STAFF REPORT: OCTOBER 8, 2025 MEETING

APPLICATION NUMBER: HDC2025-00305

ADDRESS: 6108 28th STREET

SCOPE: REPLACE 42 STEEL WINDOWS WITH ALUMINUM-CLAD WOOD WINDOWS, REPLACE WINDOW WALL

Architect's measured drawings of **existing** window types proposed for replacement, from submitted materials. Some proposed replacement window elevations are shown on the draft order form in the application materials.

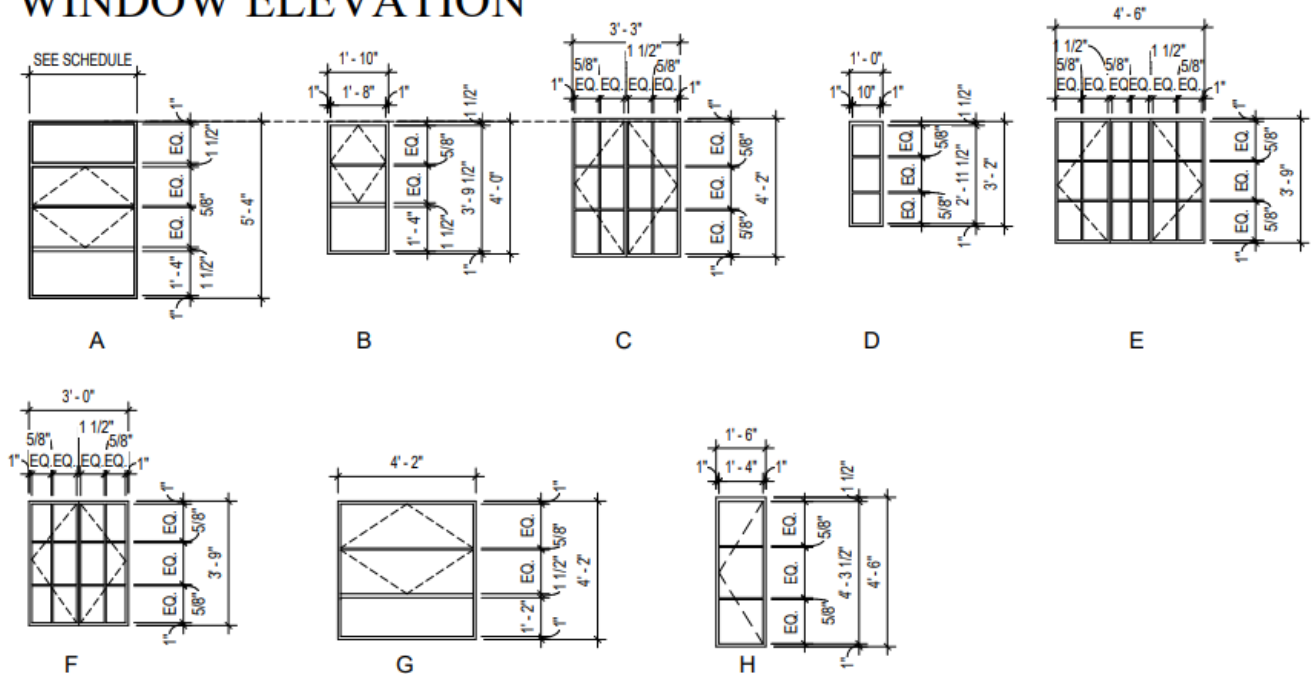
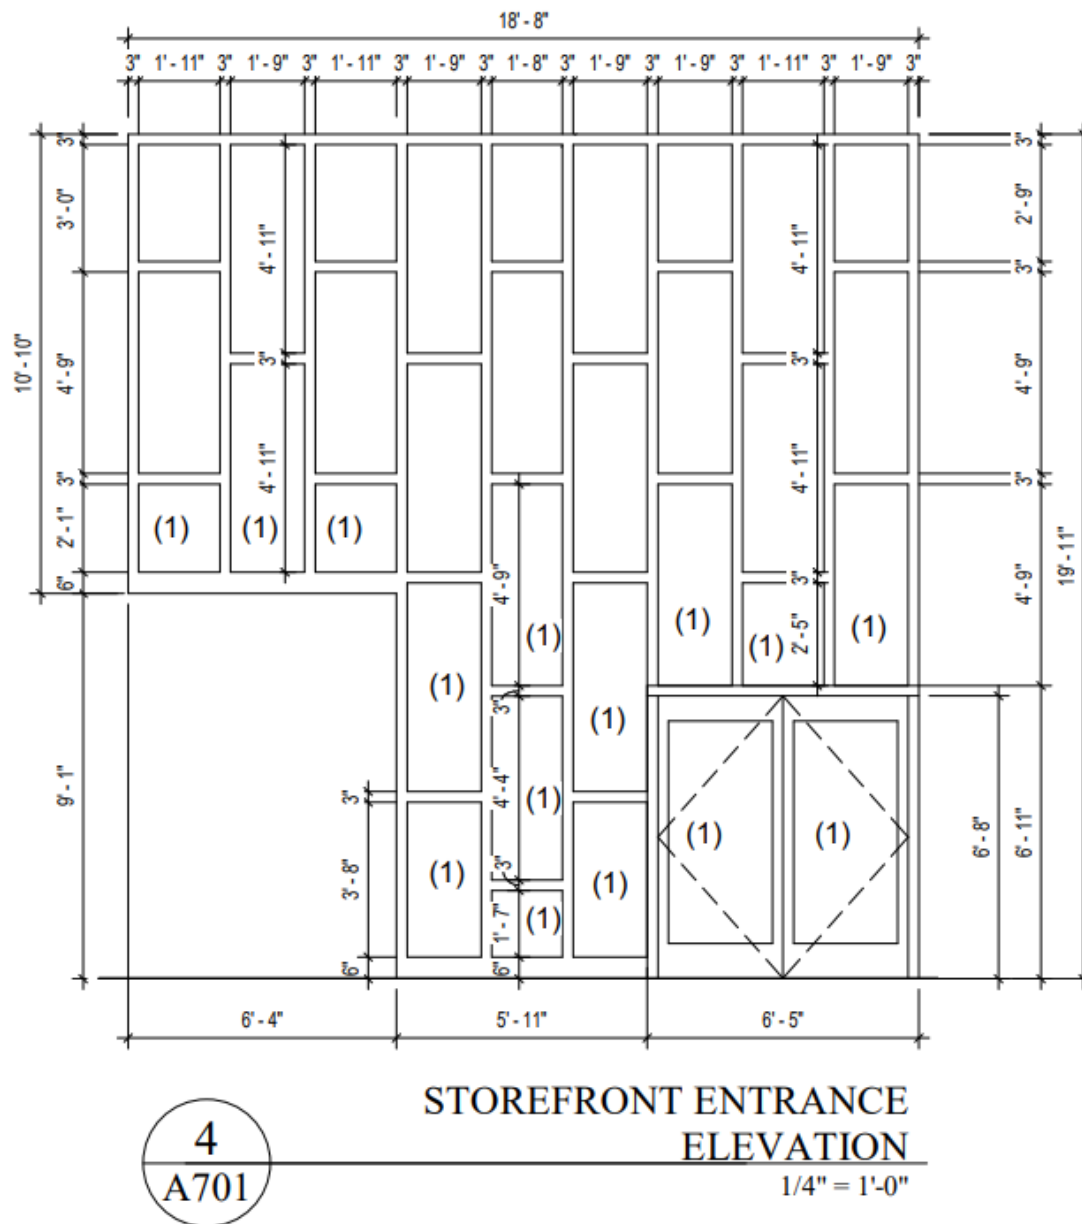
The clear **windows in the church's 1938 portion** are steel windows with 5/8" muntins. The proposed replacements have 7/8" muntins. The historic windows are recessed into the window openings quite deeply (this is mentioned in the district's Elements of Design), and the replacements for all windows are proposed to be recessed into the openings to match the existing. The proposed windows, however, are 5" thick and staff suspects the steel windows are much thinner; staff isn't sure that the window openings would accommodate a 5-inch-thick window to be placed in the opening *and* allow for the same recess as the steel windows have. According to the quantities and window types listed on the window schedule in the architectural drawings, the 1938 window types proposed to be replaced are Window types W4 (6 of these), W5 (9 of these), W7 (6 of these), W8 (3 of these), and W11 (2 of these) for a total of 26 windows from 1938 proposed for replacement.

Another example of replacement windows not quite matching the historic are the W5s shown on the architectural drawings in the basement below the sanctuary and on the window order. Their historic configuration is 6 panes wide and three tall, but the proposed configuration is only four panes wide and three tall. The proposed replacements in this case emphasize the horizontal instead of the vertical, and the proportions are changed. A couple other

The **windows in the 1963 portion** also have 5/8" center muntins, and they also commonly have two horizontal 1.5-inch bars (one above and one below the thin muntin). The proposed replacements for all of these 1963 windows have uniform 7/8" muntins. The 1963 window types shown on the architectural drawings are Window Types W1, W2, W3, and W9. (Samples from the materials are shown below). Proposed for replacement are five W1s, eight W2s, one W3, and two W9s for a total of 16 windows to be replaced from 1963.

- Design. The muntins are similarly sized (7/8s” new for 5/8s” historic), but the configuration of the muntins, the framing around the window, and the recess resulting from the way the new window would be installed in the opening might all create differences between the historic windows and the proposed replacements.

- It seems to staff that the appearance of the 1963 windows with the horizontal muntins can be more accurately replicated by the replacement windows than that of the 1938 windows. Staff notes here and in the attached spreadsheet that not every proposed replacement window is shown on the draft window order provided. Of the 1938 replications provided, however, staff has noted above that in at least two instances, the window configurations (and proportions) will be different than the historic.

- Design—all of the replacement windows need to be shown in their entirety on a complete window quote with sufficient detailing, and the proposed window configurations and designs need to more closely replicate the original 1938 windows. Inconsistencies like the sanctuary windows being excluded from the project scope but included on the draft quote will need to be eliminated. A detailed drawing showing the complete replacement window wall system with entry doors in place would help ensure that the finished replacement system would properly and compatibly replace a historic feature that was determined to be beyond repair.

- Recessing and dimensionality—sufficient documentation should show that for both 1938 and 1963 steel windows, the placement of the proposed replacement windows in the window openings will match the historic so that the historic recesses are preserved, per the district's Elements of Design. Likewise, the window wall system must preserve and retain the location of the glass panels within the aluminum system. Additionally, all muntin details on replacement windows must be permanently applied to the glass's exterior to preserve dimensionality and shadow lines.

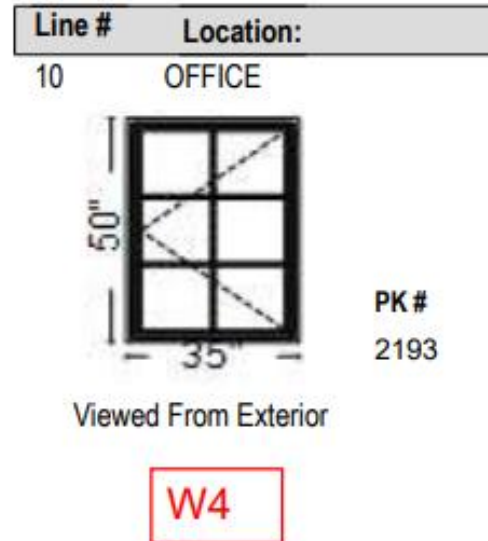
The **1963 window wall** is composed of 3-inch-wide aluminum framing and 1'11" x 4' 11" glass rectangular panes (some cut to fit) installed in a staggered layout. Some panes have colored film applied or non-glass inserts to appear as stained glass. Staff is not clear as to whether the glass panes in the existing window wall are flush with the aluminum framing or (more likely) recessed. The proposed replacement aluminum framing for the new window wall is 2" wide. It is not clear to staff if the proposed storefront can replicate the existing window wall's staggered pattern or if the new storefront system for the window wall would require all the glass to be in a straight stacking grid-like layout. In the new proposed replacement, the glass can be recessed up to 3.5" into the frame, or the panes can be installed flush with the frame. It is not clear if the stained glass effect will be replicated in the proposed replacement.

The **1963 aluminum doors** have horizontal members (rails) that measure 3.5" tall and vertical members (stiles) that measure 3.5 wide, and the remainder of the door is glass. It appears to staff that the bottom rail of the 1963 door might be a little taller than the top rail—perhaps it is 4" tall. In the proposed replacements, the door's top rail is 2 1/8" tall, the stiles are 2 1/8" wide, and the bottom rail is 4" tall in the standard door, but that can be customized.

concern necessitates an entire replacement window wall, staff is unsure. The historic aluminum framing is three inches wide and the proposed aluminum framing is two inches wide. It is unclear to staff reviewing the Tubelite materials if the historic design with almost 2' x 4' panels of glass could be installed in a staggered pattern. The recessing (if any) of glass panels and whether the stained glass effect could or would be replicated are questions staff doesn't see answered in this proposal. Staff notes, however, that multi-colored glass is mentioned in the Elements of Design and in the district's final report, so stained glass or a stained glass effect in this 1963 entry would likely be required.

- If the elements of the 1963 glassed-in vestibule are beyond repair, it is staff's opinion that a drawing showing the new proposed entry vestibule in place would be helpful to assess its compatibility. Staff understands that the size of the proposed new vestibule would not be different from the old, but understanding how its new glass panels would look in their frames on site using the new proposed system would be helpful to assess proportion and compatibility.

- Pattern—the staggered rectangle layout and pattern of the glass (some accented with color) in the glass window wall system is a character-defining feature and must be preserved.
